ADDENDUM No. 5

MBWWTP SOLIDS PROCESS OPTIMIZATION IMPLEMENTATION PHASE 2 THICKENER UPGRADES CONTRACT NUMBER W-16-017-201

CITY OF CHATTANOOGA, TENNESSEE

SLUDGE THICKENERS
NO. 1 AND 2
DEMOLITION AND
MODIFICATION SECTION

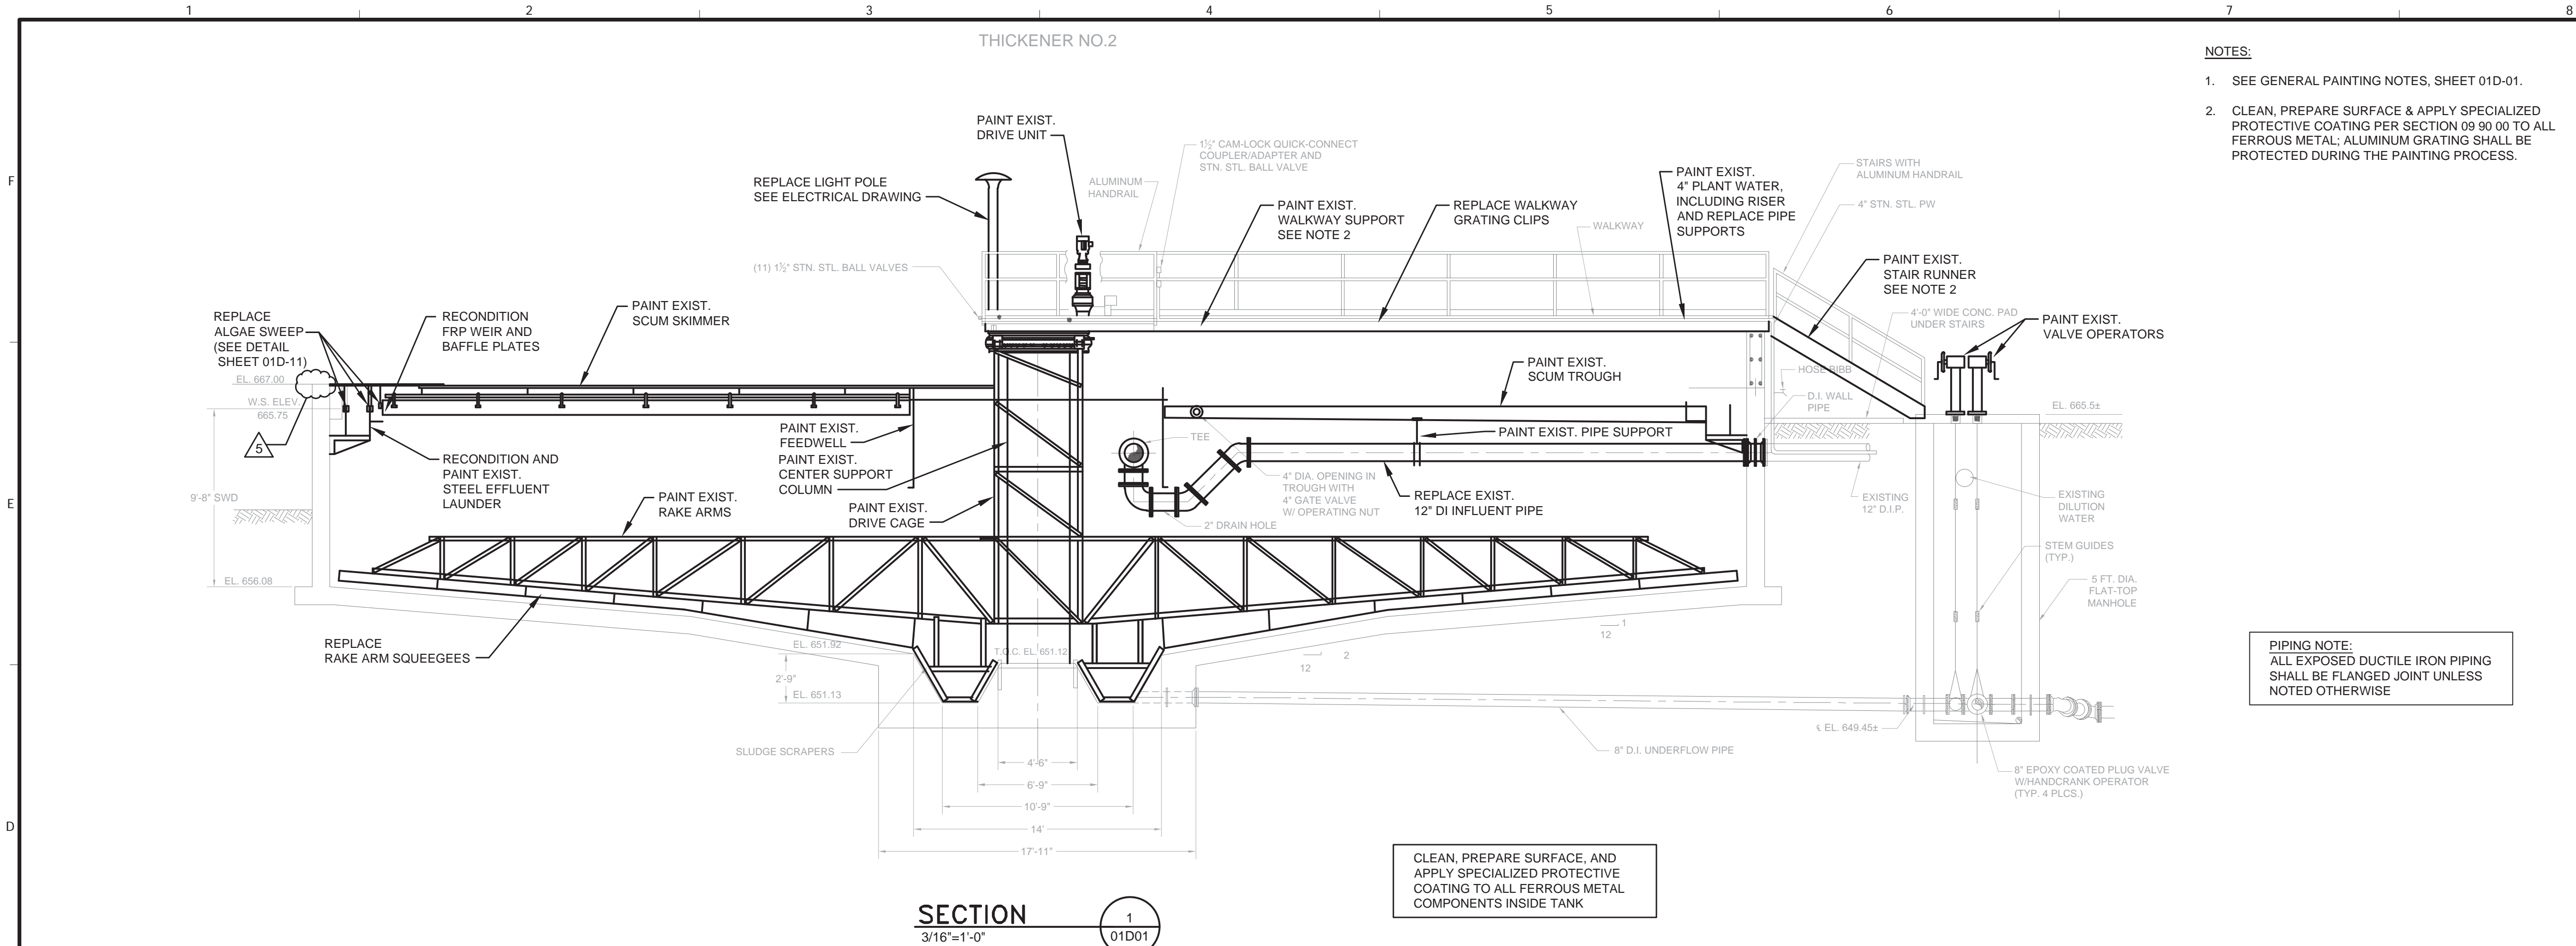
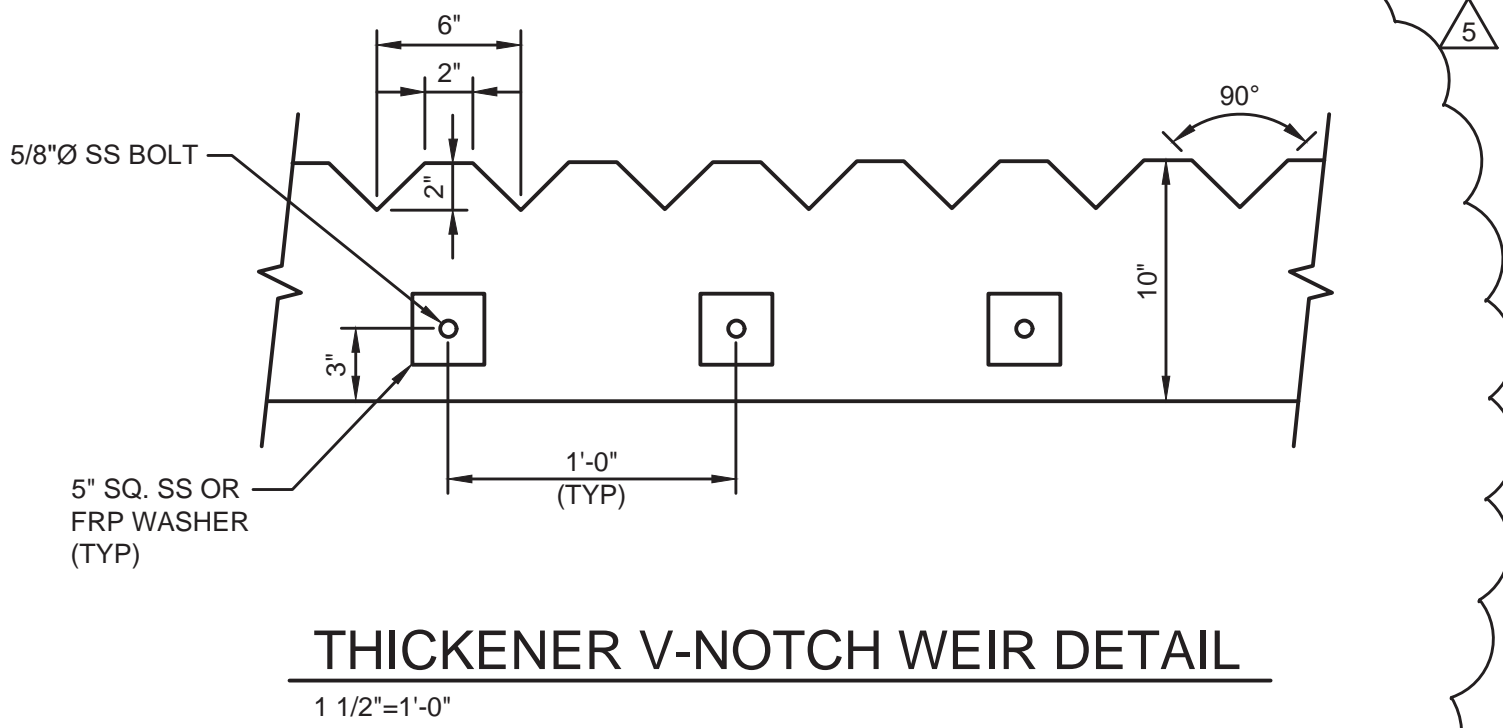
9. **Replace Contract Drawing 01D-02 with the attached revised version.** Revised version includes a details added for the launder, weirs and baffles. Make the additional changes as detailed in this addendum.

10. Revise Contract Drawing 01D-02 with the following:

Delete the following note: "Recondition FRP Weir and Baffle Plates" and replace with "Remove, clean, and reinstall existing weirs and baffles. Install new stainless steel hardware and mounting brackets and insure no interference with new Algae Brush Cleaning system manufacturer. Replace sections of FRP weir and baffles that are deemed to be deteriorated past useful life. Replacement sections will be determined upon inspection and approval of Engineer. Replacement sections are paid per the associated unit price pay item. See Schedule on this Sheet."

Delete the following note: "Recondition and paint exist. steel effluent launder" and replace with "Remove, clean, prepare surface and paint existing steel launders and launder supports. Reuse existing launder support anchors and protect from cementitious rehabilitation products. Cut, patch and weld section of the steel launders that are deemed to be deteriorated past useful life. Replacement area will be determined upon inspection and approval of Engineer and paid per the associated unit price pay item for launders and allowance pay item for launder supports. See Schedule on this Sheet."

Delete the following note from the top/center of the page: "Paint Exist Drive Unit" and replace with the following "Replace Thickener Drive Motor per 01E-02. Paint Thickener Drive Gear Box."

Add "Replace Full Radius Skimmer Blades and Wipers (2 each tank)" at the end of the following note: "Paint Exist. Scum Skimmer."

Add the following note 3 under "NOTES" at the right side of the page: "3. All work shown applies to Thickener Tanks 1 & 2."

Add the attached "Thickener Tank 1 & 2 Schedule" to the bottom of the Drawing 01D-02.

THICKENER EFFLUENT LAUNDER DETAIL
1 1/2"=1'-0"

3/4" DIAMETER ANCHOR BOLTS TO REMAIN
ON THICKENERS NO. 1 AND 2. FOR
THICKENERS NO. 3, 4, AND 5, CUT
EXISTING ANCHOR BOLTS FLUSH WITH
CONCRETE, PAINT END WITH
BITUMINUMOUS MATERIAL, AND INSTALL
NEW 3/4" DIAMETER SS ANCHOR BOLTS
WITH EPOXY GROUT.

- NOTES:
- DETAIL SHOWS BOTH THE NEW EFFLUENT LAUNDER ARRANGEMENT AT THICKENERS 3, 4, AND 5 AND THE EXISTING EFFLUENT LAUNDER ARRANGEMENT AT THICKENERS NO. 1 AND 2.
 - REPLACE ALL BOLTS AND FASTENERS SHOWN ABOVE ON THICKENERS NO. 1 AND 2. NEW HARDWARE SHALL BE STAINLESS STEEL AND MATCH DIAMETER OF EXISTING. CONTRACTOR SHALL COORDINATE BOLT LENGTH AND BAFFLE BRACKETS WITH ALGAE SWEEP MANUFACTURER TO ENSURE THERE IS NO INTERFERENCE.

- NOTES:
- DETAIL SHOWS BOTH THE NEW WEIR FOR THICKENERS 3, 4, & 5, AND THE EXISTING WEIR FOR THICKENERS 1 AND 2.
